Re: Porch Plan Review & Structural Specifications

104 Sherman Pines Dr, Fuquay-Varina, NC 27526 - Harnett Co.
Project #: 23091 - Revision 1-7/7/23

Ledger Attachment Detail

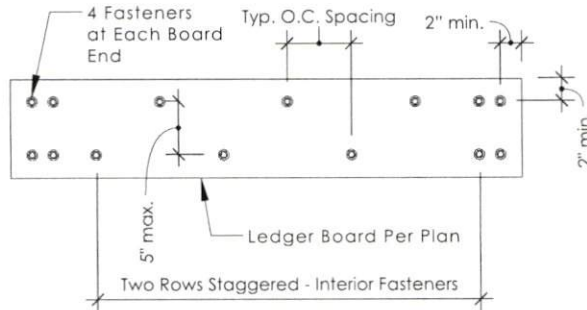
3. Required Deck Floor System Framing:
 - Deck floor joists shall be P.T. 2x10's @12" O.C.
 - Attach a 2x12 ledger board to the existing house using the ledger attachment detail at the end of this report.

"Y" Bracing Detail

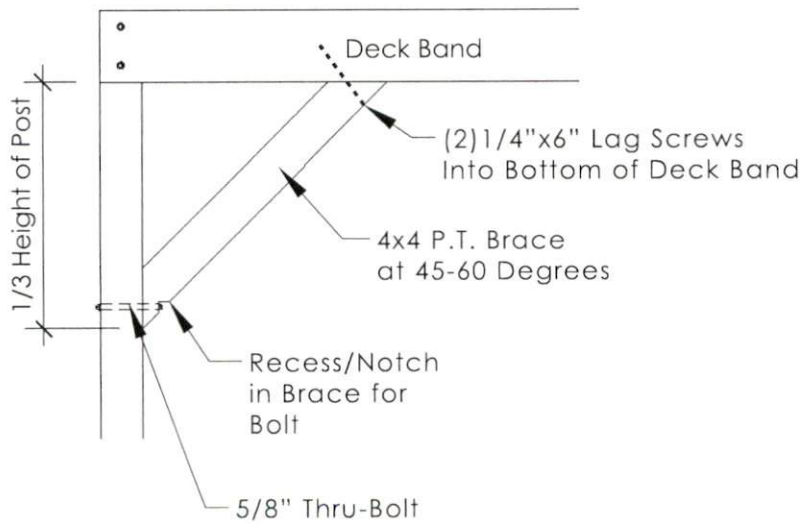
- 8x8 P.T. support posts shall have "Y" bracing attached at each corner parallel with the rear wall of the house. Refer to the "Y" bracing detail attached at the end of this report.

Footing Detail

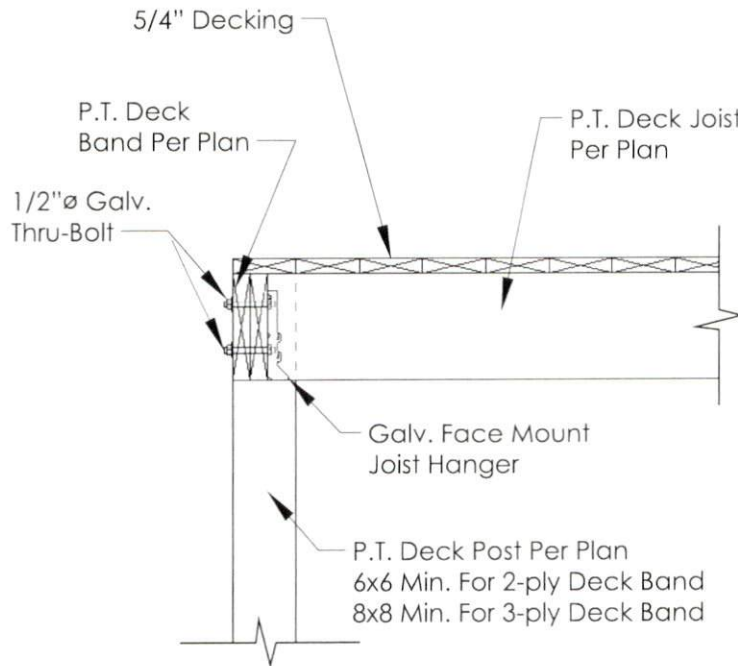
- The 8x8 posts shall be supported according to the footing detail located at the end of this report.
